Of an application by CJ Industries Ltd for land use consent RM200488 for gravel extraction and associated site rehabilitation and amenity planting and for land use consent RM200489 to establish and use vehicle access on an unformed legal road and erect associated signage

EVIDENCE OF SIMON JAMES AIKEN ON BEHALF OF CJ INDUSTRIES FLOODING

15 July 2022

Figure 2: Motueka and Riwaka 2D model extent (in red). Labelled parts of the extent polygon show lumped catchment inflow locations (in green) and downstream boundary location (in blue).

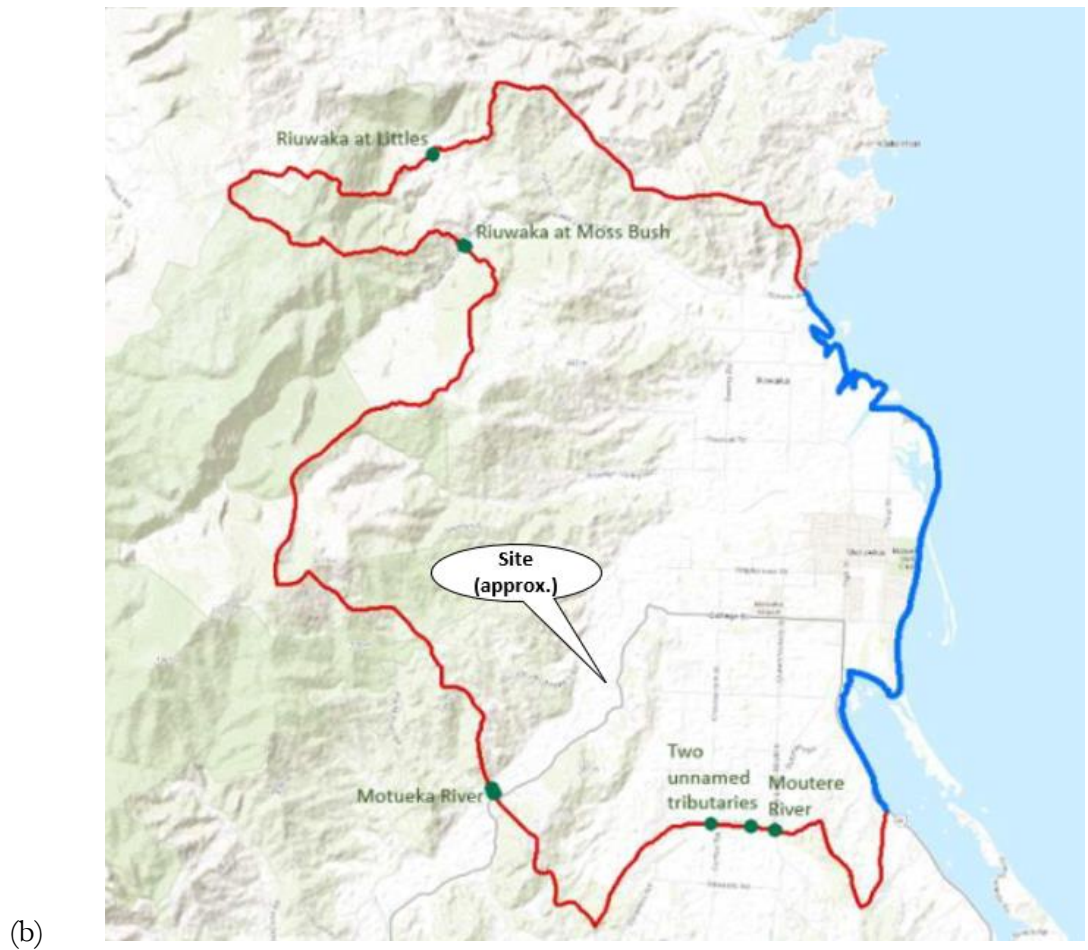
- 3.24 In general, most submitters raised generic queries related to flooding and flood risk which I have addressed above or are addressed by the analysis in the T+T report. However, Dr Michael Harvey raised a series of more technical queries and I explicitly respond to these below.
- 3.25 **Issue:** “Additional coincident flows in the floodway from significant local west bank tributaries are probably not included in the model”

- (a) This statement is incorrect. The hydraulic model includes coincident flows from the west bank tributaries. The extent of the model was schematised to include the urban areas of Motueka and Riwaka and surrounding floodplains. Flows from six upstream catchments are assessed through lumped catchment hydrology and introduced to the model as point sources at the hydraulic model boundary. The model extent and location of these six inflows is shown in Figure 2 below.

Figure 3: Location of velocity plots shown in Figures 4 and 5.

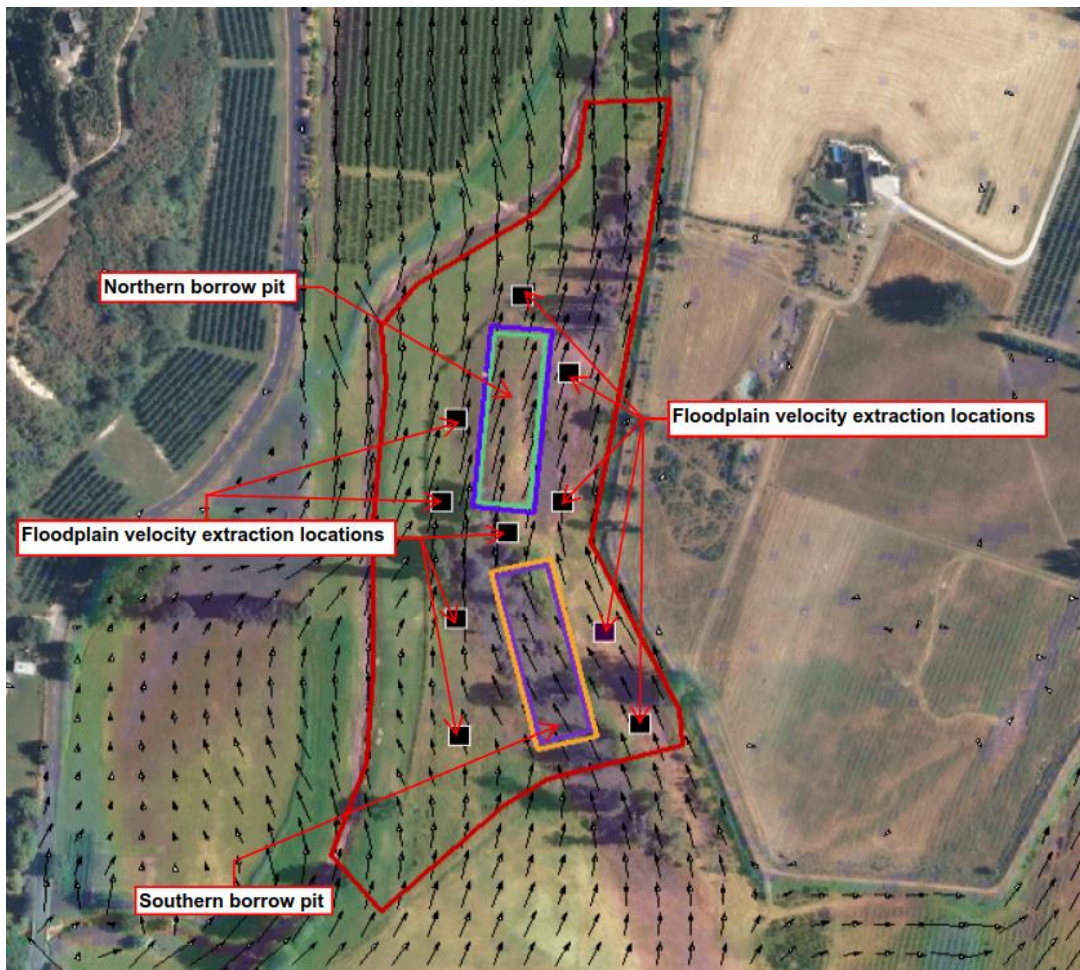
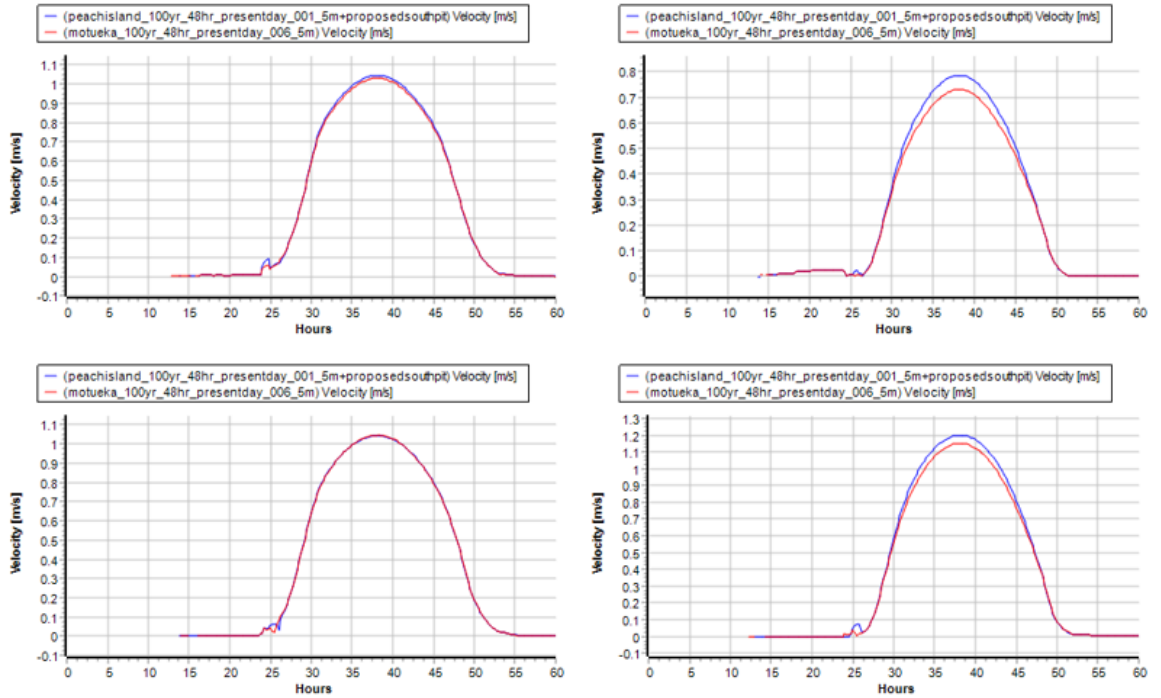
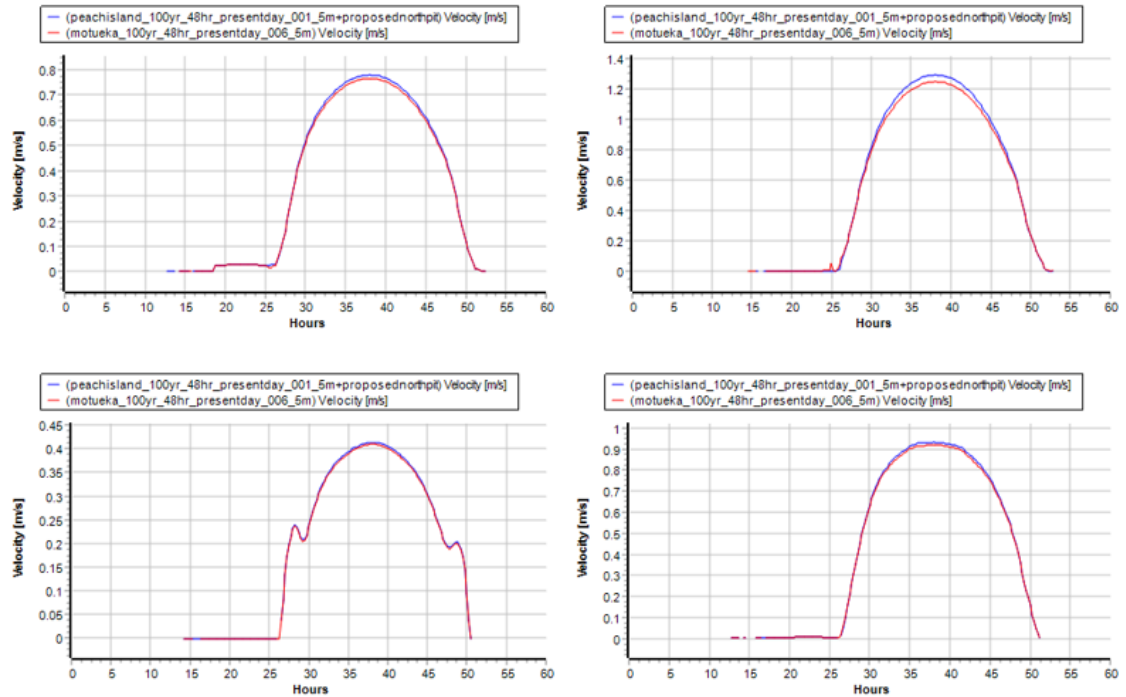
- (a) **Floodplain scour Issue:** “No analysis of floodplain scour was conducted when results of the hydraulic modelling showed reduced flow depths and increased velocities immediately upstream of the south pit (i.e. increased shear stress). Presentation of the results as changes between existing and proposed conditions does not provide absolute values of depth or velocity with which either critical velocity or shear stress can be assessed for what are clearly sandy soils (Landvision, Ltd, May 2021 report). Velocities in excess of 0.6 m/s are likely to cause erosion of bare sandy soils and it appears that velocities of 0.7-0.8 m/s are predicted during the 100-yr ARI event (T&T, p.5)”

- (i) The original T+T report did not present absolute values in our discussion of floodplain hydraulics or scour. To address this query, I have extracted time varying (Figure 4 and Figure 5) plots of velocity from the hydraulic model at several locations on the floodplain areas adjacent to the modelled borrow pits. These plots compare velocity between the pre (i.e. existing topography) and post development case (i.e. 5 m deep borrow pit). For reference the location of the extracted data points is shown in Figure 3 below.

- (i) Each plot within Figures 4 and 5 shows four time-series plots for velocity (i.e. changes in velocity over a time at location). The red line shows the velocity for the existing topography and the blue line shows the velocity with the activity and its extraction (borrow) pits in place. Each plot shows data extracted from different locations (shown as black boxes on Figure 3) on the floodplain. Figure 4 relates to the southern extraction (borrow) pit in Figure 3. I have repeated this query for the modelled northern borrow pit in Figure 5.

- (ii) These plots illustrate negligible change in both absolute velocity values and the temporal flow pattern between the existing (pre) and post development scenarios across the wider floodplain and hence negligible change in shear stress and erosion effects

Figure 6: Time-series plot of velocity for model cell immediately adjacent to the modelled proposed borrow pits. The plots show the velocity on the vertical axis over time on the horizontal axis over the 1% 48-hour design storm.

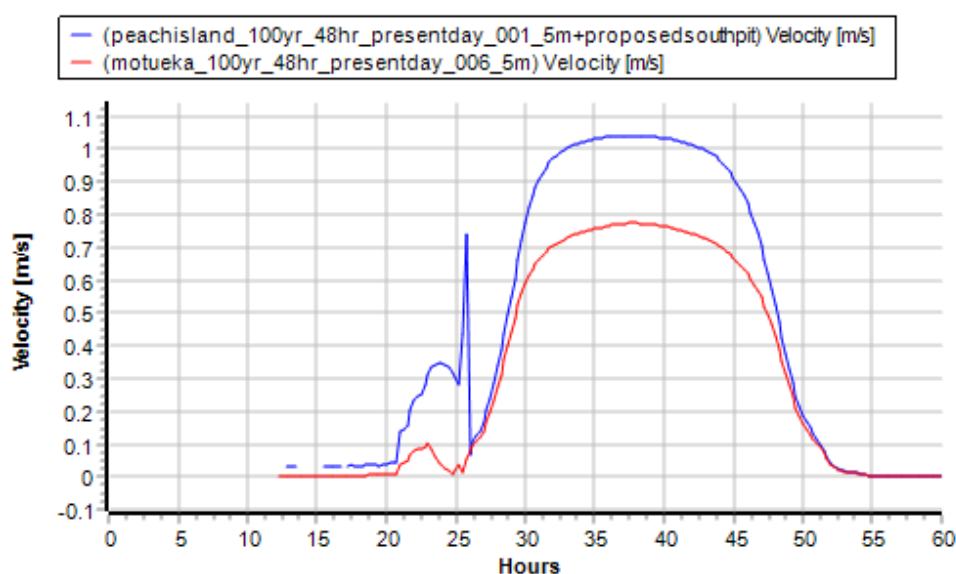
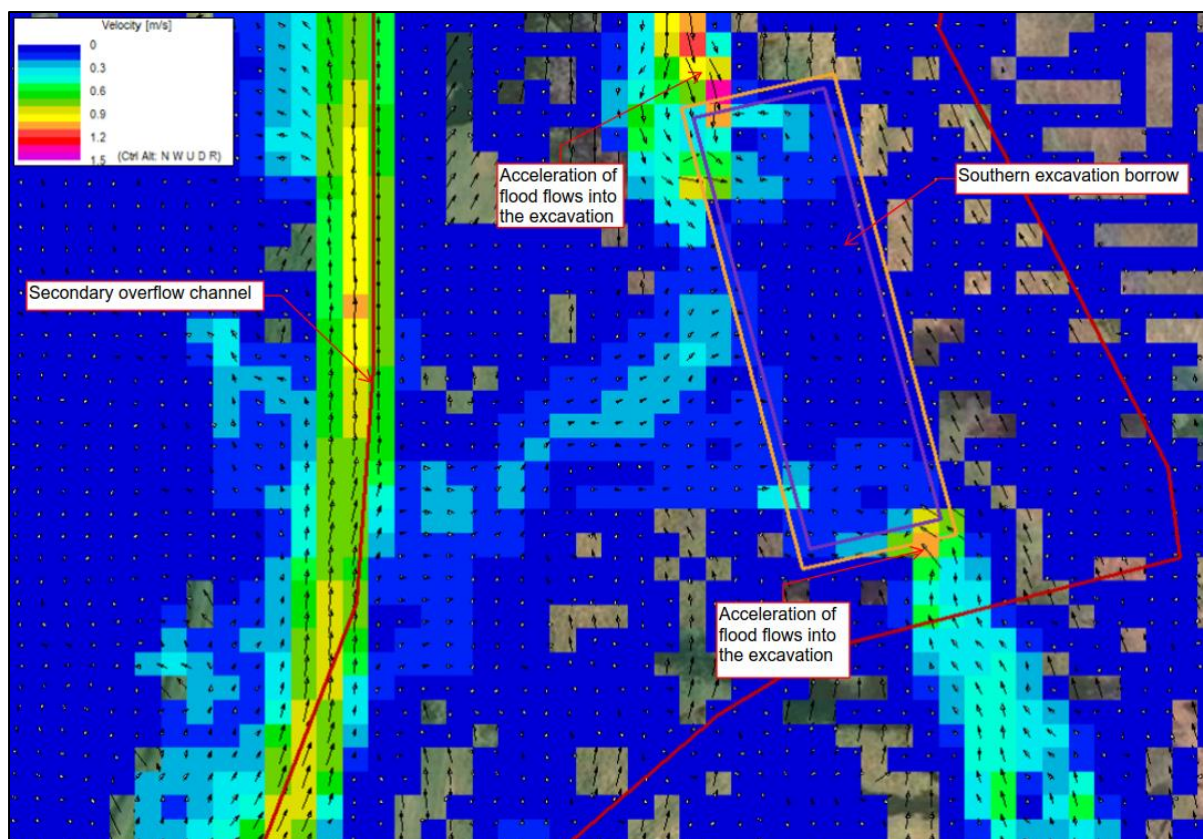
Issue: Dr Harvey noted that the T+T report reported flow velocities in the order of 0.7-0.8 m/s.⁴ He considered this to be an issue.

This number relates to velocities only to the south of the southern borrow pit. It is the peak relative (not absolute) change in velocity at any one time across the entirety of flood duration and is related to acceleration of flood flows into the borrow pit at the 25 hr time step, as the borrow pit fills with water. This can be seen in Figure 6.

This increase is for a short period of time compared with the overall flood duration. While there is an increase of velocity 0.2 – 0.3 m/s for the remainder of the event. This is an average flow velocity over the full depth of the water, in reality the velocity at the base will be lower. The increase in velocity is temporary until the excavation is full and velocities return to normal.

Figure 8: Peak flood levels during the 1% AEP (existing design storm).

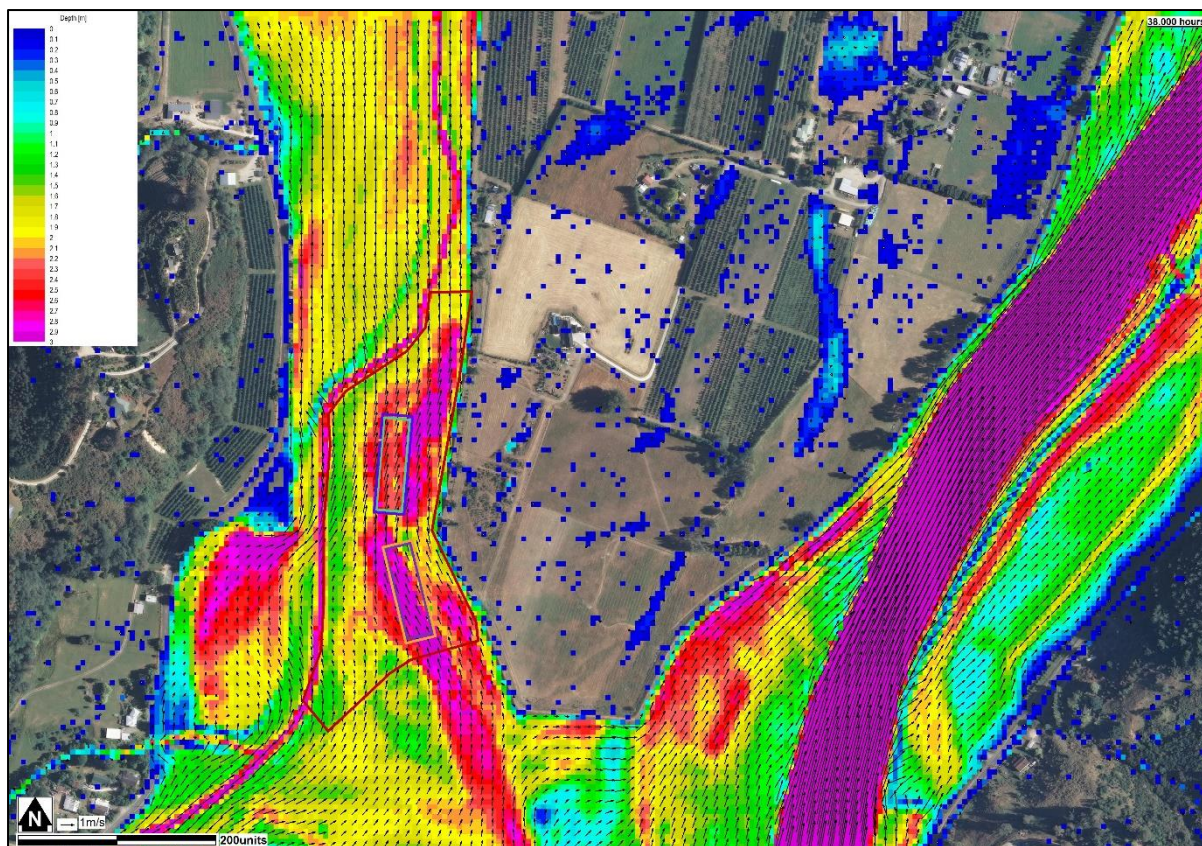
3.27 The issue raised in the s 42A report that I have not already addressed is the potential impacts of flooding from Stages 2 and 3 if the stopbank overtopped. This issue was raised in light of submissions that that a 1 % AEP event had a 15 % chance of occurring and that was not insignificant' over the term of the consent.

- (a) I acknowledge that over the 15-year period for which consent is sought there is a 15 % probability that the 1 % AEP event may occur.
- (b) The starting point is that in any weather event, the stopbanks at the site provide a degree of protection for the stage 2 and stage 3 excavations.
- (c) The stopbank will overtop in events greater than exceed the design standard, regardless of the proposed activity.
- (d) Modelling of the 1 % AEP flow event does not show overtopping of the stop bank around the site (Figure 8).
- (e) Regardless, the proposed activity has been shown to not fundamentally change the performance of the floodplain, increase the risk of overtopping or failure of the stopbanks. Therefore, I consider the assessment of effects on the stopbank overtopping during an event that exceeds the design criteria is not necessary.
